# Access Compliance Report

## Public Rights-of-Way

Intersection ID: 17306	Main Street: ELECTRA_LN	Cross Street: BUICK_DR	Location: S
ADA ID: 07C694F586D7	Ramp Type: PerpDiag	Initial Pass/Fail: Fail	Overall Compliance: No
Severity Score: 12.5			
Codes/Mitigation Info/Possible Solution		Field Measurements/Component Compliance

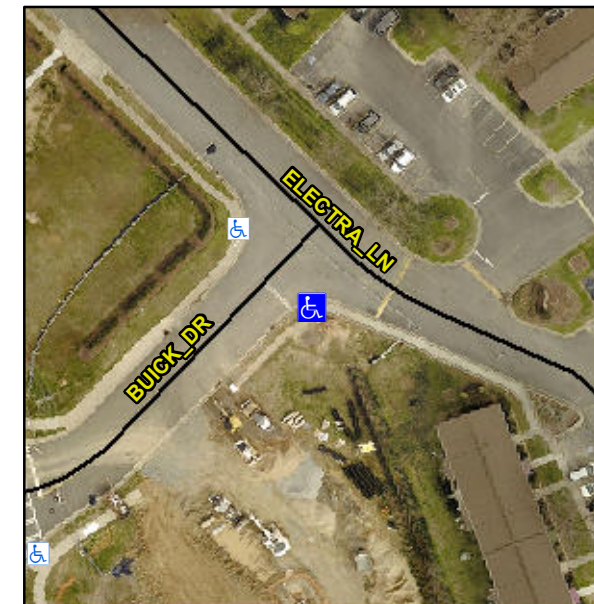
**Not Found, R304.2.2**

Compliance	Description	Data	Compliance	Description	Data
N/A	Ramp Length (in)	42.0	No	Ramp Slope (%)	9.5
Yes	Ramp Width (in)	48.0	Yes	Ramp XSlope (%)	0.2
N/A	Flare Type LT	N/A	N/A	Flare Type RT	N/A
N/A	Flare Slope LT (%)	N/A	N/A	Flare Slope RT (%)	N/A
N/A	Flare Traversable LT?	N/A	N/A	Flare Traversable RT?	N/A
N/A	Landing Length (in)	N/A	N/A	DWS Provided?	N/A
N/A	Landing Width (in)	N/A	N/A	DWS Contrast?	N/A
N/A	Landing Slope (%)	N/A	N/A	DWS Length (in)	N/A
N/A	Landing X Slope (%)	N/A	N/A	DWS Full Width?	N/A
N/A	Landing Curb? (Y/N)	N/A	N/A	DWS Offset (in)	N/A
N/A	Shared Landing?	N/A			
N/A	Gutter Ponding?	N/A	N/A	Gutter Slope (%)	N/A
N/A	Gutter Lip Ht (in)	N/A	N/A	Gutter X Slope (%)	N/A
N/A	Painted X Walk1?	No	N/A	Painted X Walk2?	No
	X Walk 1 Direction	To NE		X Walk 2 Direction	To NW
N/A	X Walk 1 Width (in)	N/A	N/A	X Walk 2 Width (in)	N/A
	X Walk 1 Slope (%)	5.2		X Walk 2 Slope (%)	3.0
	X Walk 1 X Slope (%)	0.2		X Walk 2 X Slope (%)	3.1

**Remove & Replace Curb Ramp With Two New Directional Ramps or Equivalent.**
